UNITED STATES PATENT AND TRADEMARK OFFICE

APPLICATION NO.	FILING DATE	FIRST NAMED INVENTOR	ATTORNEY DOCKET NO.	CONFIRMATION NO.
10/791,870	03/04/2004	Yoshio Ozawa	04329.3260	5239
22852	7590	06/23/2005		EXAMINER
FINNEGAN, HENDERSON, FARABOW, GARRETT & DUNNER LLP 901 NEW YORK AVENUE, NW WASHINGTON, DC 20001-4413			HO, TU TU V	
			ART UNIT	PAPER NUMBER
			2818

Office Action Summary	Application No.	Applicant(s)
	10/791,870	OZAWA, YOSHIO
	Examiner Tu-Tu Ho	Art Unit 2818

DETAILED ACTION

FIG. 3F

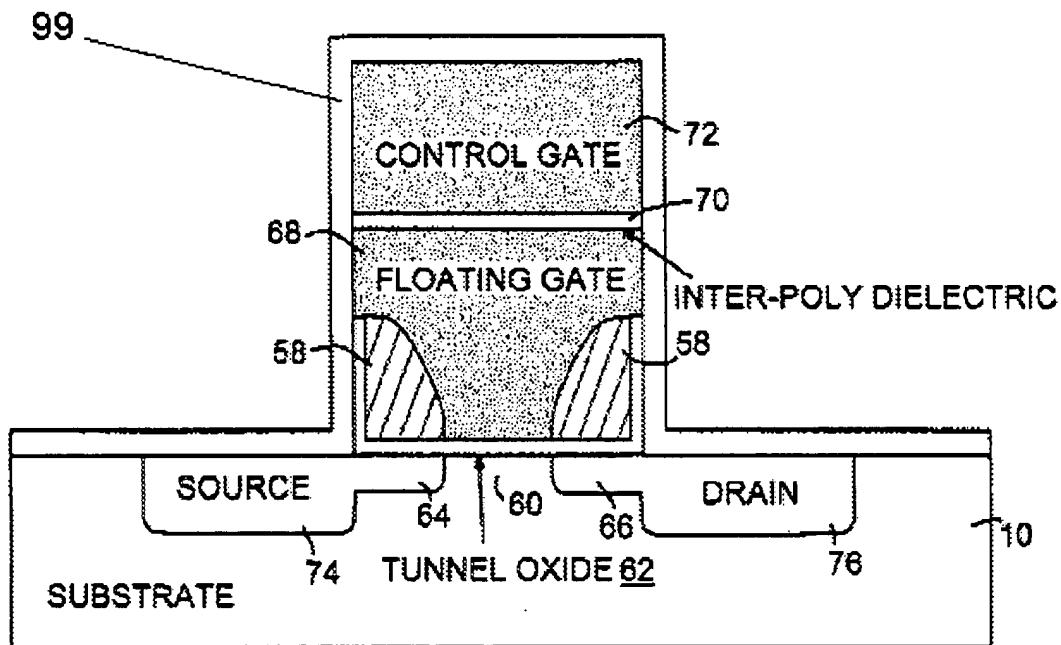
Referring to **claims 1 and 4**, the '904 reference discloses in Figures 3's, particularly Fig. 3F, and respective portions of the specification a nonvolatile semiconductor memory cell comprising:

a semiconductor substrate (10);
a stacked-gate structure that includes a tunnel insulation film (62, column 3, line 42), a floating gate electrode (68), an inter-electrode insulation film (70) and a control gate electrode (72), which are stacked on the semiconductor substrate; and
gate side-wall insulation films (58/99) formed on both side surfaces of the stacked-gate structure,

wherein the thickness of the gate side-wall insulation film (58/99) increases, at a side portion of the floating gate electrode, from the inter-electrode insulation film (70) side toward the tunnel insulation film side, and the width of the floating gate electrode in a channel length direction decreases from the inter-electrode insulation film side toward the tunnel insulation film side.

Note: 99 is added by the examiner for ease of explanation.

However, the reference fails to teach that the inter-electrode insulation film (70) has a three-layer structure that includes a first oxidant barrier layer, an intermediate insulation layer and a second oxidant barrier layer.

Referring to **claim 5**, the '904 reference further discloses that the gate side-wall insulation films (58/99) comprises a first side-wall insulation film (58) that is provided on a side surface of the floating gate electrode (68), and a second side-wall insulation film (99) that is provided on a side surface of the control gate electrode (72).

Referring to **claim 3**, as is evident for Fig. 3F, the inter-electrode insulation film (70) has a substantially flat structure, and an area of the tunnel insulation film, which contacts the floating gate electrode (68), is about 70% or less of an area of the inter-electrode insulation film, which contacts the floating gate electrode.

Looking at Fig. 3F of the '904 reference, modified in view of Zheng and Kim as noted above to have the three-layer inter-gate insulation film of claim 1 and the two-layer control gate electrode of claim 6, at a stage before formation of a second side-wall insulation film marked as 99 by the examiner (see above). In other words, at this stage, the combined teachings disclose all limitations except for the second side-wall insulation film as recited in claim 9, which second side-wall insulation film is thin at upper and lower surfaces of the control gate electrode lower layer, and thick at a central part of the control gate electrode lower layer. The '904 reference further discloses the required source region 74 and drain region 76.
